POND BROOK ESTATES SUBDIVISION

Newtown, Connecticut

Environmental Review Team Report

November 2002

Figure 10.

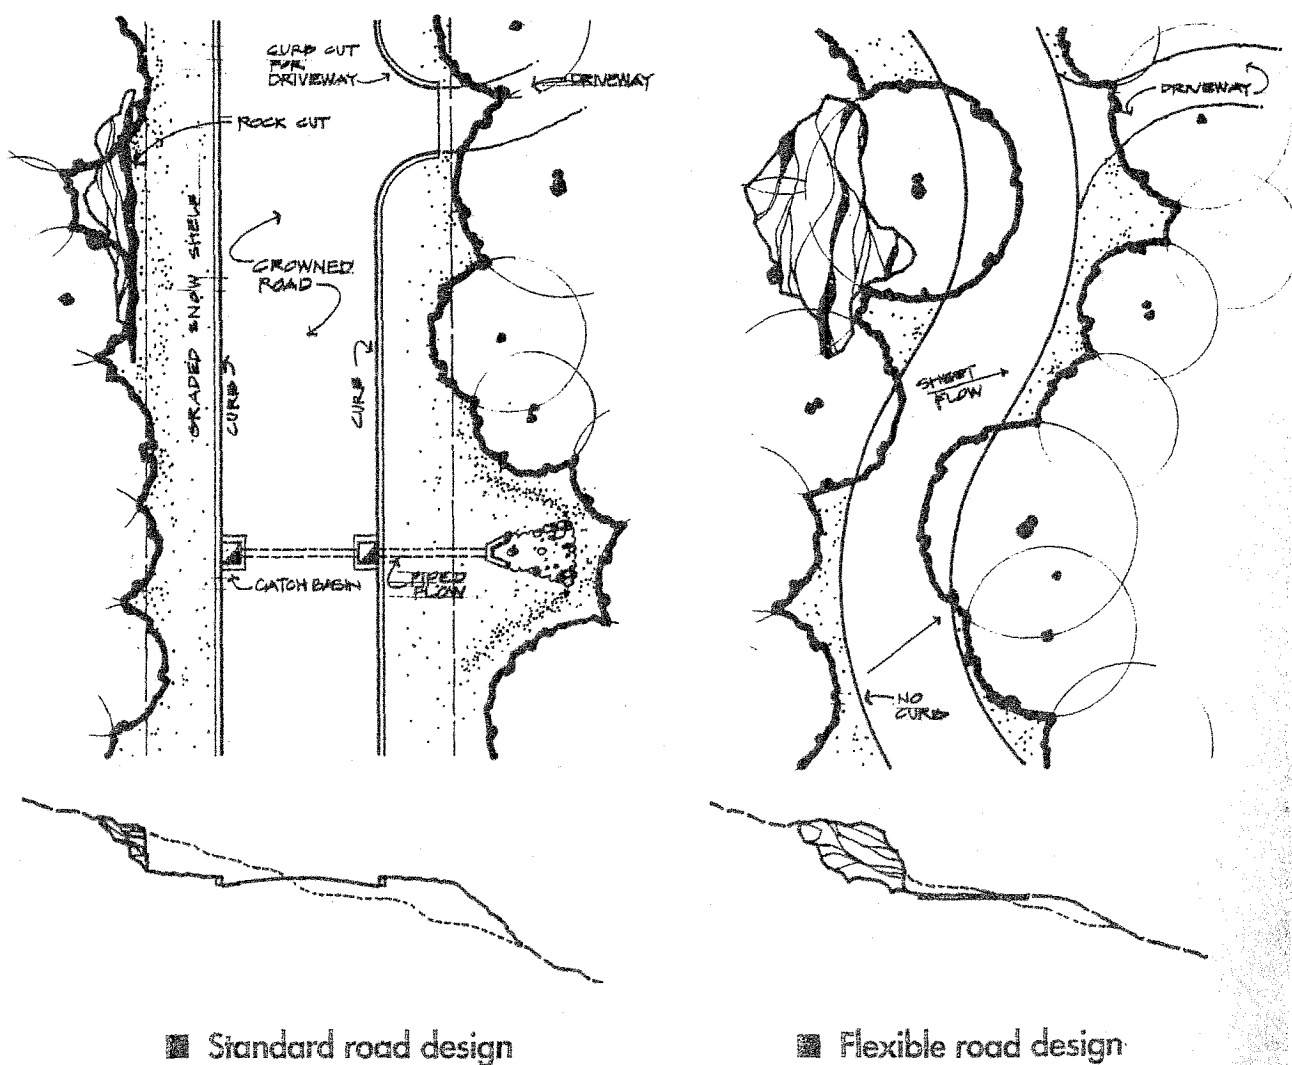
Locating houses to minimize driveways and other site disturbances and flexibility in road and driveway design (Figure 9) can assist in minimizing the amount of impervious surfaces and maintain a rural road character. Eliminating road curb and catch basins wherever possible disperses runoff and further

minimizes impact on water quality, can reduce initial costs and result in less long-term maintenance and replacement costs. (Figure 10)

Figure 11.

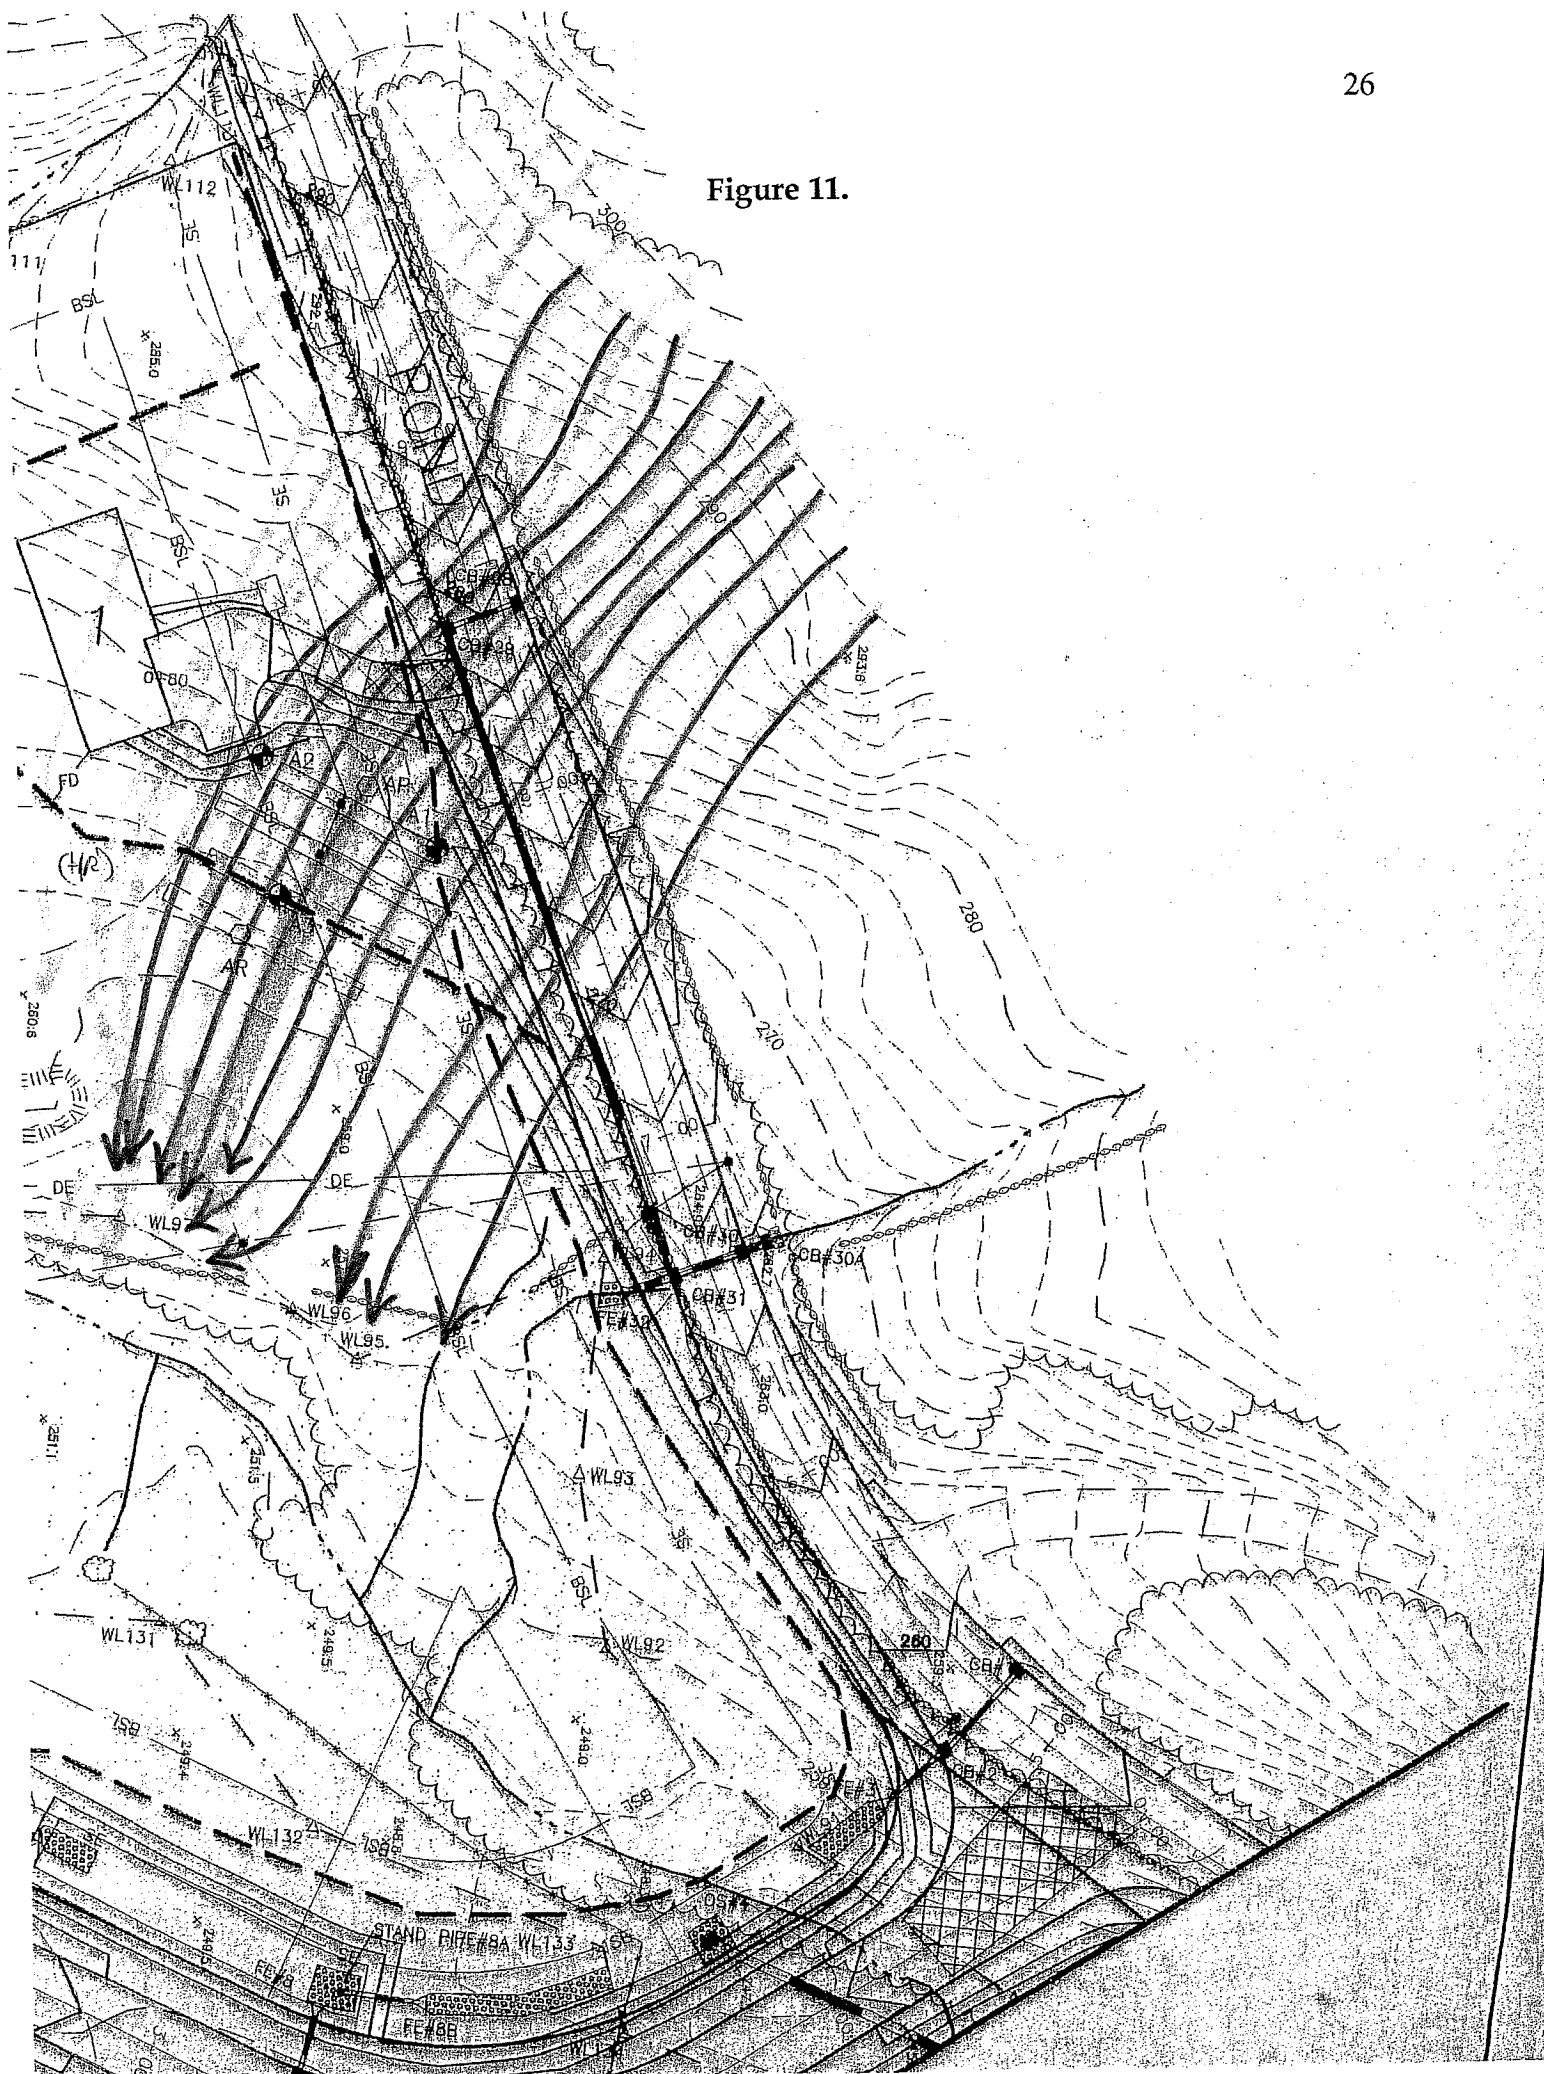
The natural drainage in the area of proposed lot one concentrates surface runoff from upland areas as the runoff approaches the wetland area. (See Figure 11) This indicates an area of marginal soils, with seasonal high water tables expected to be 20 inches below the surface. Soils in the area of the proposed septic system are likely to have a low permeability substratum (perched water table). The design of and location of the system for lot one should be considered carefully and the design requirements of the system detailed to demonstrate engineering requirements and potential costs. Surface water flows should be directed away from the leaching field, or preferably, the system should be moved from the area of concentrated flow.

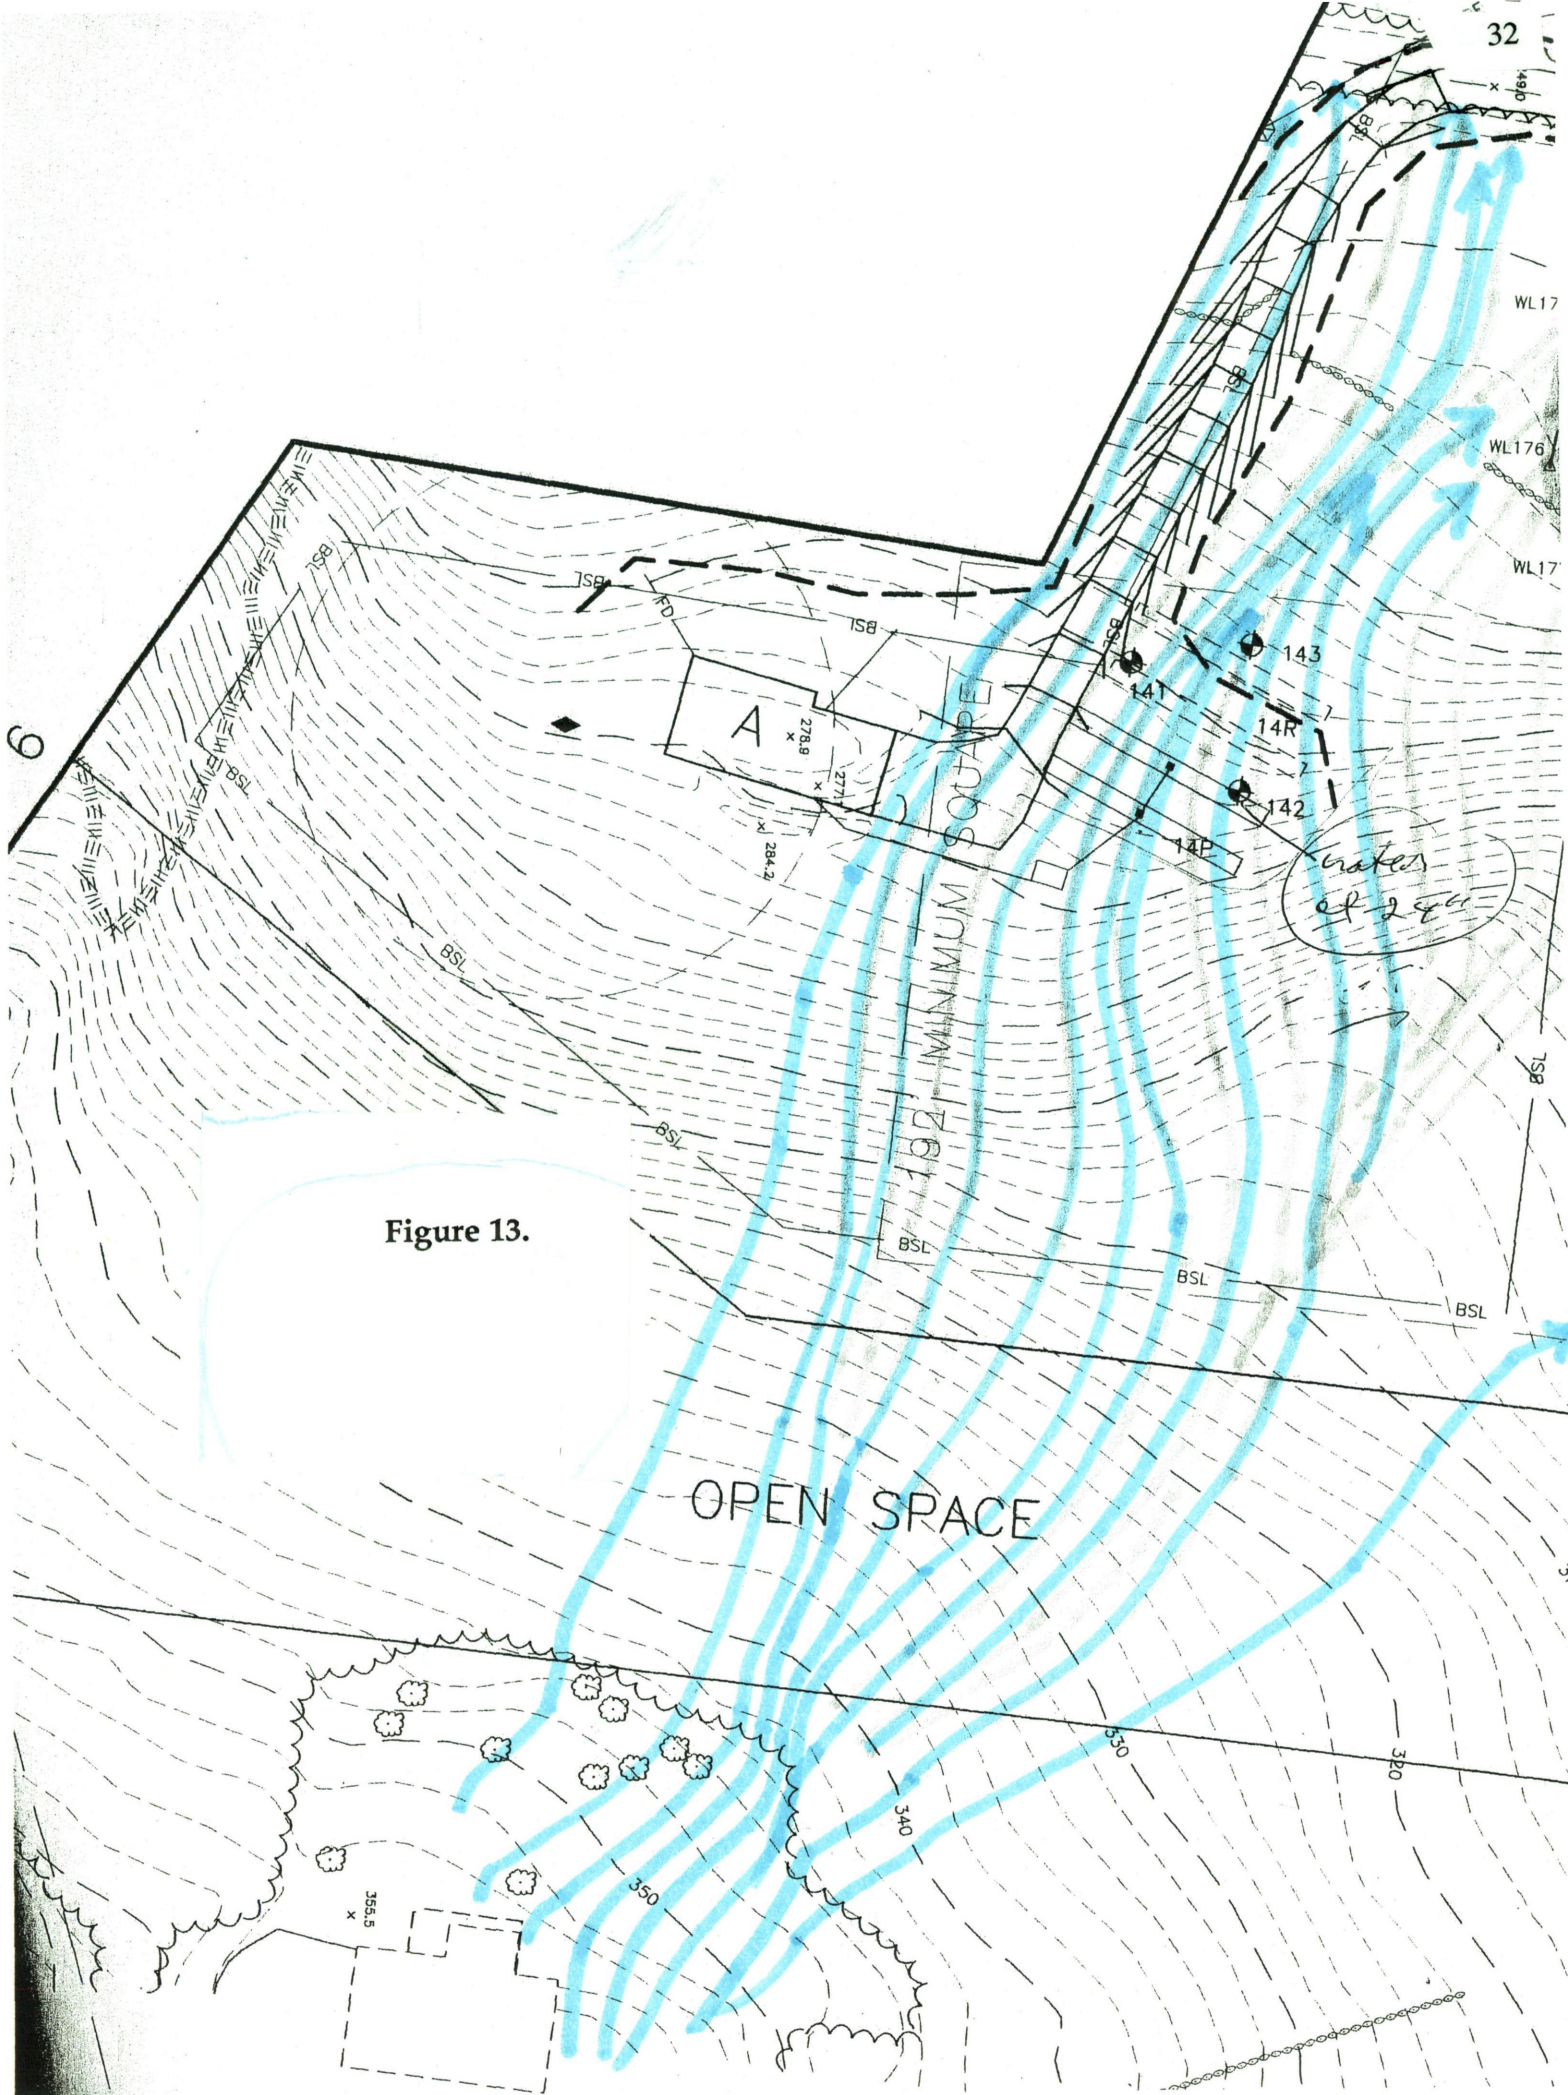
Soil tests indicate that the septic system is in an area of marginal soils and engineering details should be shown. The driveway slopes steeply and is indicated as being on the property line of lot 12. Runoff should be directed away from the adjoining property and closely located neighboring house; details should be shown. The 100 foot buffer around the well overlaps the neighboring well buffer. Detail of the grading of the septic tanks and leaching field should be shown. Provided diagrams show the leaching field upslope from the house and tanks, further engineering detail should be required. The septic tanks are shown in the same location as the replacement system.
